Docket Item # 2 BAR CASE # 2008-0147

BAR Meeting September 24, 2008

ISSUE: Alterations

LOCATION: 419 North Patrick Street

Figure 1: Existing and proposed elevations

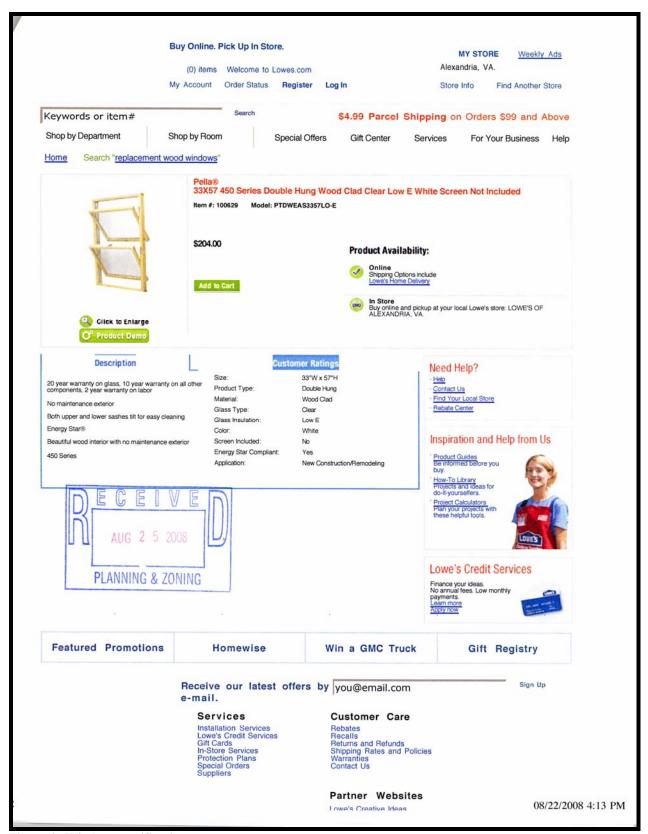
Staff supports the applicant removing the historically inappropriate bay window and door surround and replacing them with more appropriate historically compatible features. Staff commends the applicant for removing the Masonite siding, which is in poor condition. Staff has a few concerns regarding some of the details proposed as part of the renovation.

Staff does not typically recommend approval of replacement siding without evaluating the condition of the original siding, if it exists. If the original siding is in good condition, Staff recommends that it be repaired and retained, and patched where necessary. If the condition of the siding is poor, Staff recommends that the applicant install the appropriate type of wood siding, most likely German lap wood siding. The applicant should work closely with Staff to determine the most appropriate course of action once the Masonite and other layers of siding are removed.

Staff does not object to the installation of a more vernacular door surround, as this is more appropriate to the age of the townhouse. However, Staff would prefer to see the existing - and most likely historic - transom retained, even though it will remained blocked on the inside of the house due to the dropped ceiling in the applicant's living room.

- 1. That the two new windows on the first floor be wood and not wood clad on the exterior:
- 2. That the applicant work with Staff to determine whether the historic wood siding that exists underneath the Masonite and other layers of siding on the front elevation can be retained and repaired;
- 3. That, if the condition of the siding is poor, the applicant should install the same type of wood siding that was originally on the house; and,
- 4. That the original transom be retained and incorporated into the new door surround.
